Access Compliance Report

Public Rights-of-Way

(Curb Ramps)

Intersection ID: 10034401	Main Street: PIEDMONT_PARK_DR	Cross Street: POTOMAC_RIVER_PY	Location: S
ADA ID: 0065285FC8E6	Ramp Type: Directional1	Initial Pass/Fail: Fail	Overall Compliance: No
Severity Score: 25			
Codes/Mitigation Info/Possible Solution		Field Measurements/Component Compliance

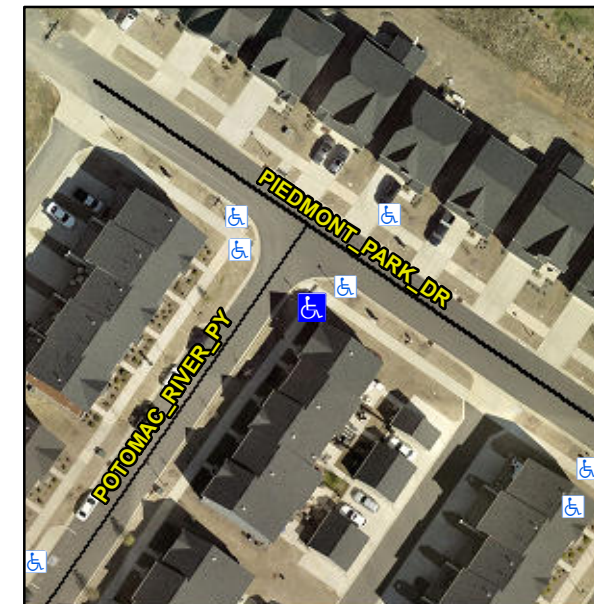
R304.2.2

Compliance	Description	Data	Compliance	Description	Data
N/A	Ramp Length (in)	34.0	N/A	Grade Break?	N/A
Yes	Ramp Width (in)	71.0	N/A	Grade Break Slope (%)	0.0
No	Ramp Slope (%)	13.9	N/A	Grade Break XSlope (%)	0.0
Yes	Ramp XSlope (%)	1.1			
N/A	Flare Type LT	N/A	N/A	Flare Type RT	N/A
N/A	Flare Slope LT (%)	N/A	N/A	Flare Slope RT (%)	0.0
N/A	Flare Traversable LT?	N/A	N/A	Flare Traversable RT?	N/A
N/A	Landing Length (in)	0.0	N/A	DWS Provided?	N/A
N/A	Landing Width (in)	0.0	N/A	DWS Contrast?	N/A
N/A	Landing Slope (%)	0.0	N/A	DWS Length (in)	N/A
N/A	Landing X Slope (%)	0.0	N/A	DWS Full Width?	N/A
N/A	Landing Curb? (Y/N)	N/A	N/A	DWS Offset LT (in)	N/A
N/A	Shared Landing?	N/A	N/A	DWS Offset RT (in)	N/A
N/A	Gutter Ponding?	0.0	N/A	Gutter Slope (%)	N/A
N/A	Gutter Lip Ht (in)	0.0	N/A	Gutter X Slope (%)	N/A
N/A	Painted X Walk1?	No		Road Slope (%)	0.7
	X Walk 1 Direction	To NW		Road X Slope (%)	2.5
	X Walk 1 Width (in)	N/A		Clear Space?	N/A

Remove & Replace Entire Ramp.
